**DRIVE BELT SQUEAKS****TECHNICAL SERVICE BULLETIN**

Reference Number(s): 10-035, Date of Issue: July 24, 2012

ACURA: 2007-12 MDX; 2007-08 TL; 2010-12 ZDX

**REVISION SUMMARY**

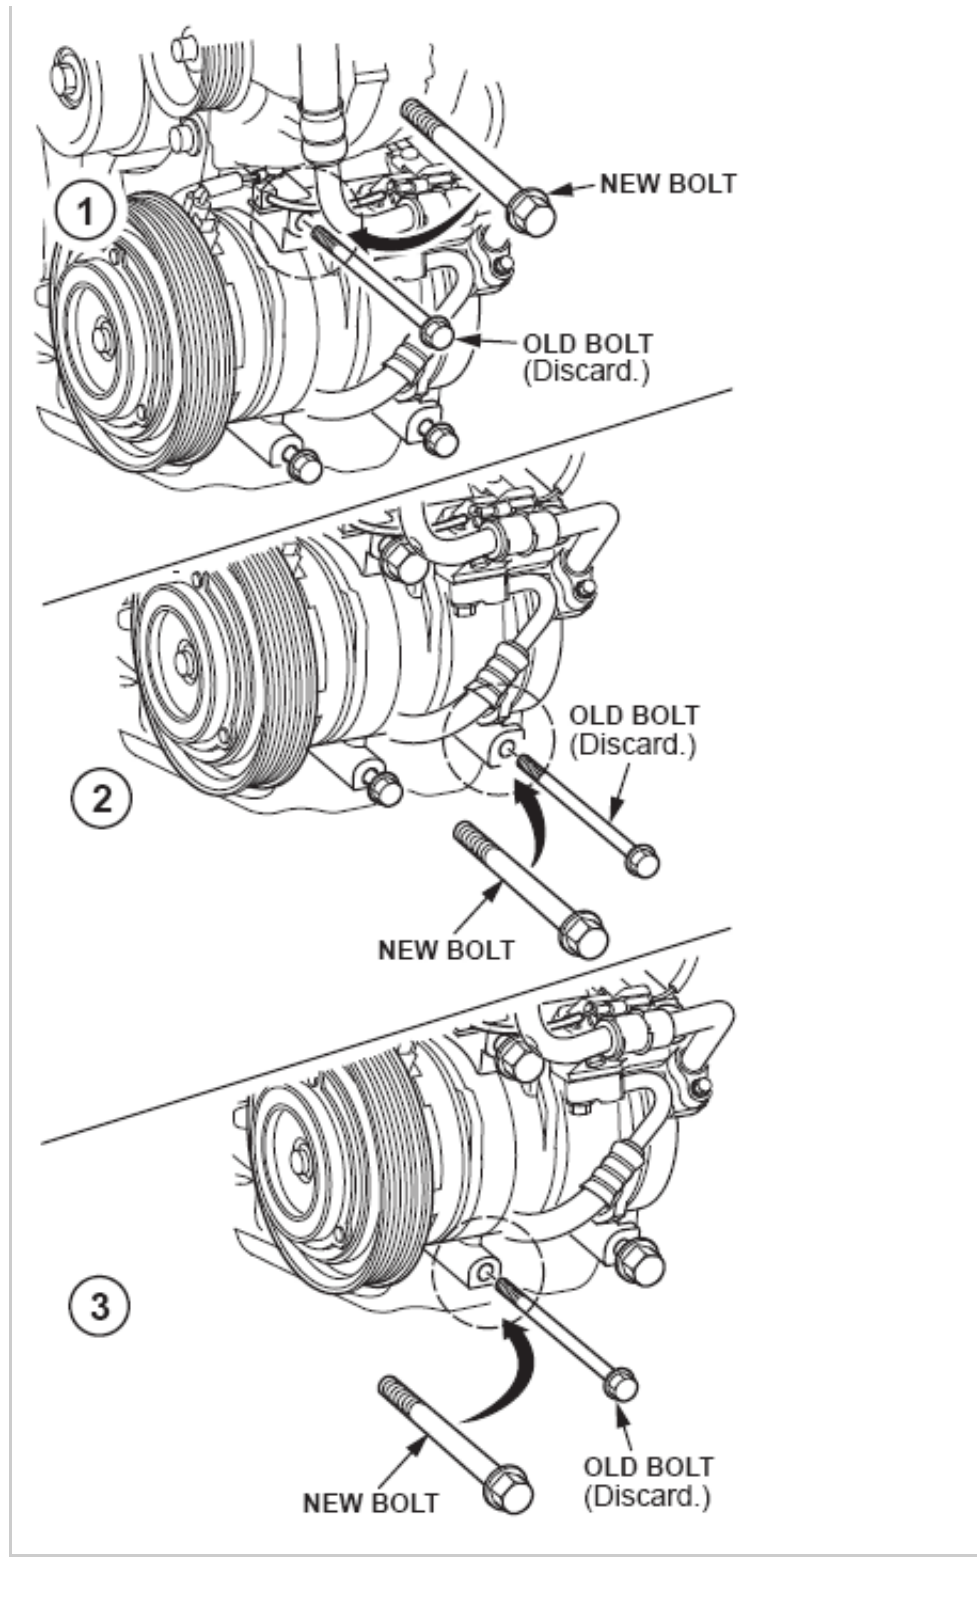
9. Replace the A/C compressor bolts with new bolts, one at a time. Tighten them finger tight. (TL shown)

1. MDX - Replace the four compressor mounting bolts as shown.
2. TL and ZDX- Replace the **accessible** compressor mounting bolts.

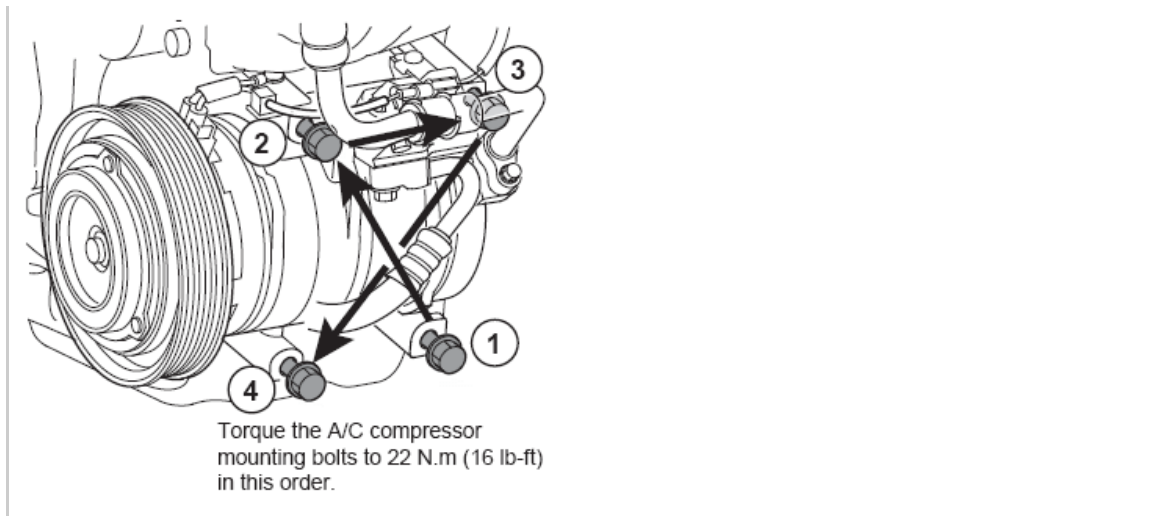
10. When you have replaced the bolts, torque them in a cross pattern to **22 N.m (16 lb-ft)**
